Access Compliance Report Public Rights-of-Way (Curb Ramps)

Main Street: GERTRUDE_DR Cross Street: KENSINGTON_RD Location: SE

ADA ID: RPRK211220142105 Ramp Type: Type 1 - Perpendicular Diagonal Initial Pass/Fail: Fail Overall Compliance: No Severity Score: 15

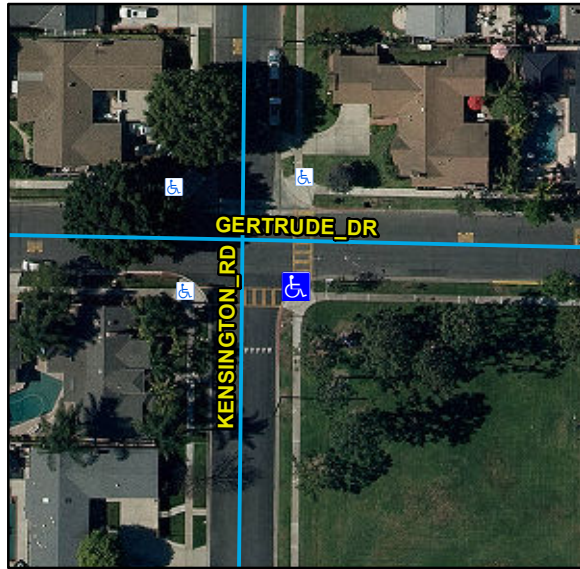
R304.2.2, R204.3, STD 1115

Remove & Replace Curb Ramp With Two New Directional Ramps or Equivalent.
